## Product Change Notice (PCN)

PCN Number: **PCN-0450470R-01**

Product(s) Affected: **PJ-014D**

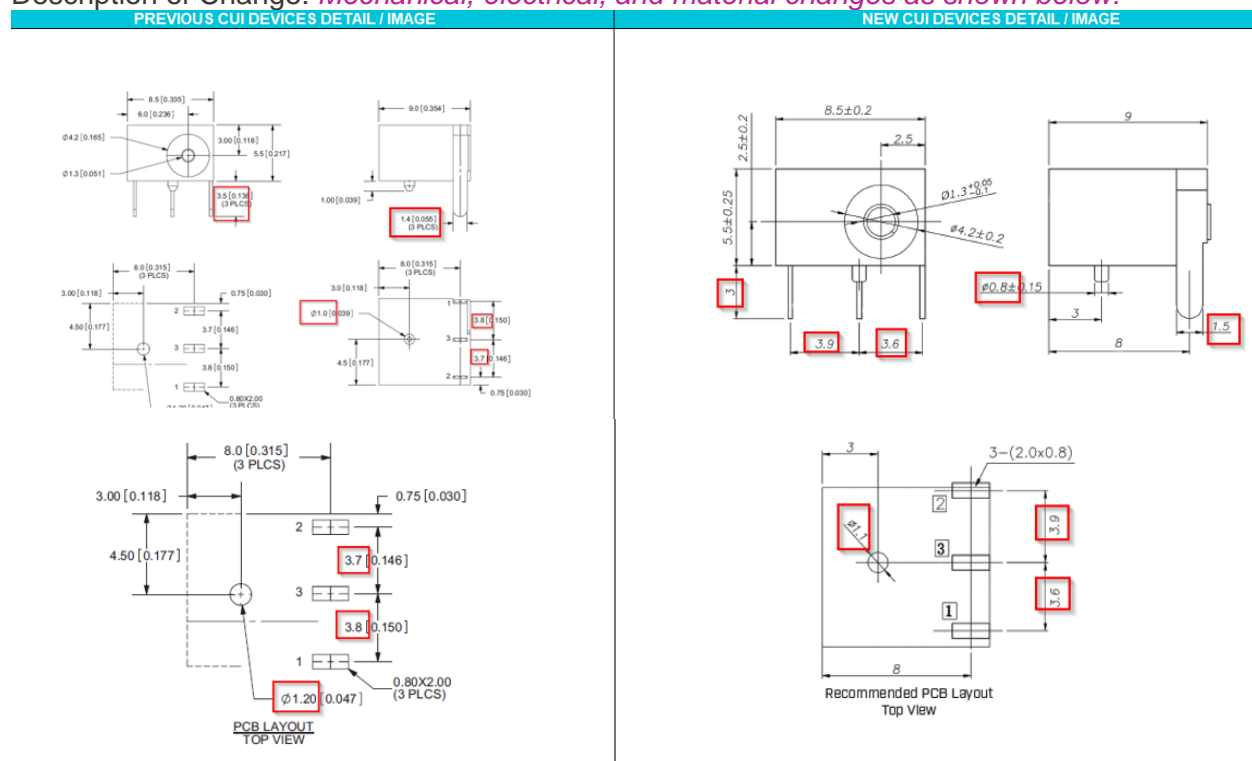
Description of Change: **Mechanical, electrical, and material changes as shown below:**

MATERIAL	PLATING
center pin	copper	nickel
terminal 1	brass	tin
terminal 2	copper alloy	tin
terminal 3	brass	tin
plastic	PBT

DESCRIPTION	MATERIAL	PLATING/COLOR
center pin	brass	silver
terminal 1	brass t=0.30	silver
terminal 2	stainless steel t=0.25	silver
terminal 3	brass t=0.30	silver
housing	PA66 (UL94V-0)	black
